Detailed Site Plan Greenbelt Square

DSP-22023

SUBJECT: Detailed Site Plan DSP-22023
Type 2 Tree Conservation Plan TCP2-009-2023
Greenbelt Square

Figure 2: Proposed Monument Sign

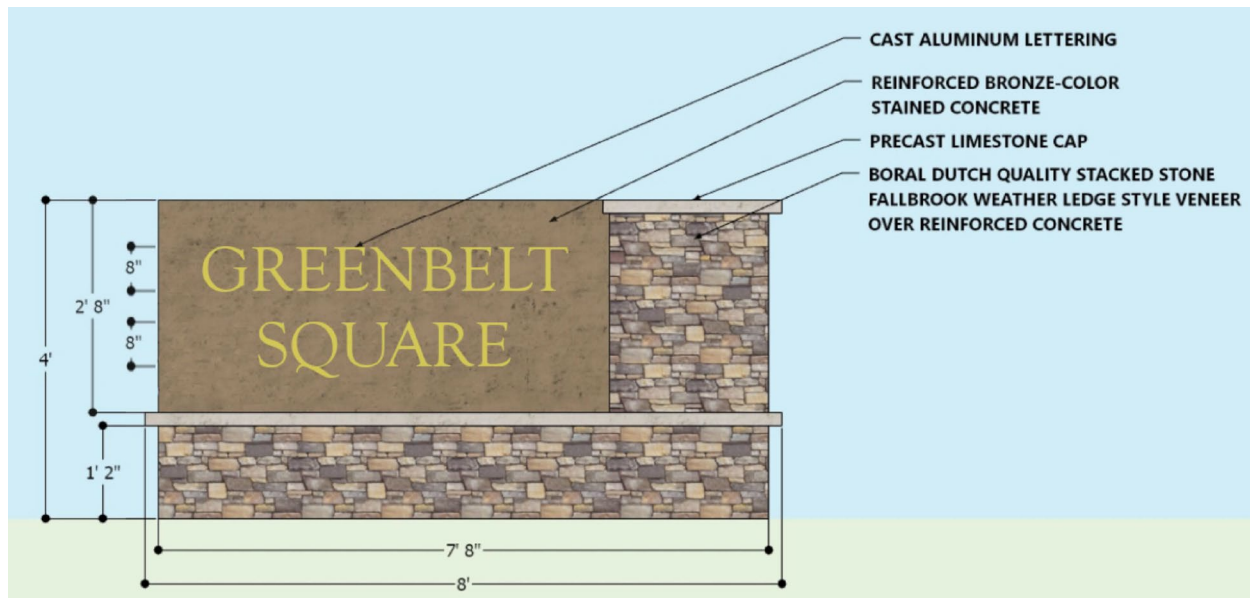
This DSP proposes one freestanding monument sign for the development. The monument sign is approximately 4 feet high and 8 feet wide. The sign materials are composed of stone veneer and stained concrete. The sign appears to be generally acceptable, and a condition has been included in this technical report requiring the applicant to provide the location of the proposed entrance sign.

- p. Provide and label the location of the entrance sign on the site plan and landscape plan
 - q. Provide a signage area schedule listing the square footage of the entrance sign.
